**REVISION 005 TO AN INVITATION TO TENDER**

<b>Title:</b> Rehabilitation of Spillway 2, Canal Lachine National Historic Site	
<b>Solicitation No.:</b> 5P201-20-0086/A	<b>Date:</b> January 11, 2021
<b>Amendment No.:</b> 005	
<b>Client Reference No.:</b> 1452	
<b>GETS Reference No.:</b> PW-20-00930900

## **Amendment 005**

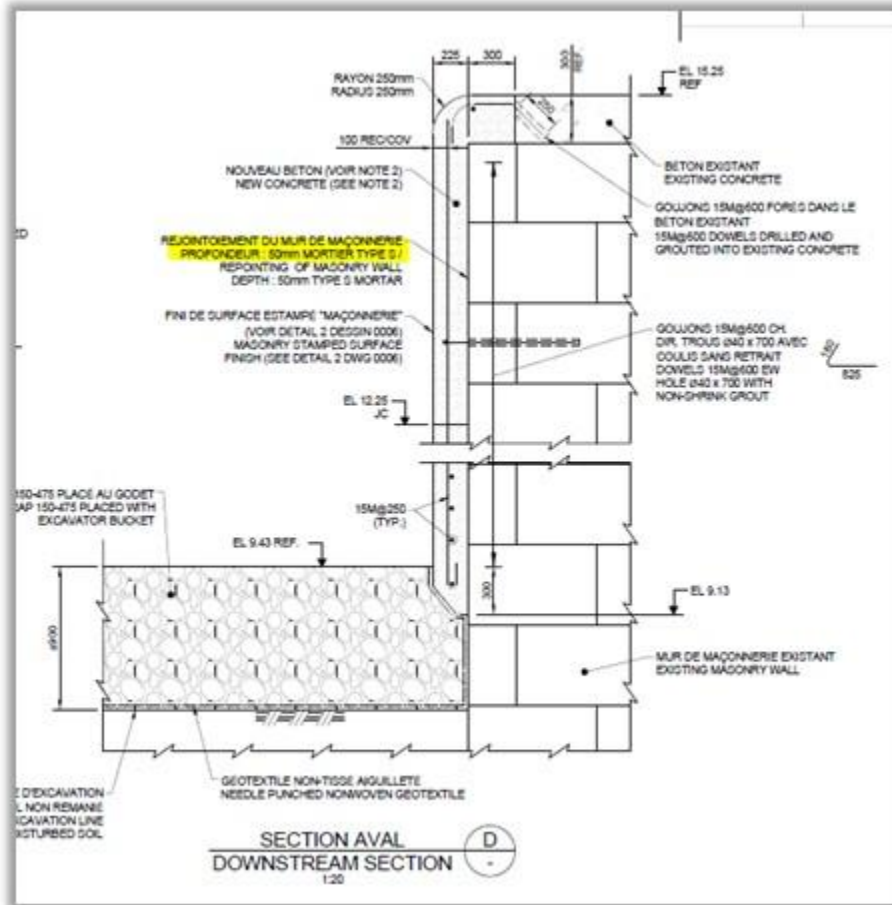
Q1 : At what location on site are the 860 linear meters of repointing (our estimated quantities are significantly lower) ?

A1: The repointing of the masonry is to be done on all joints of the masonry walls that will be receiving new concrete (see the concreting limits on drawing C5) and assumes an average stone dimension of 450mmx1000mm
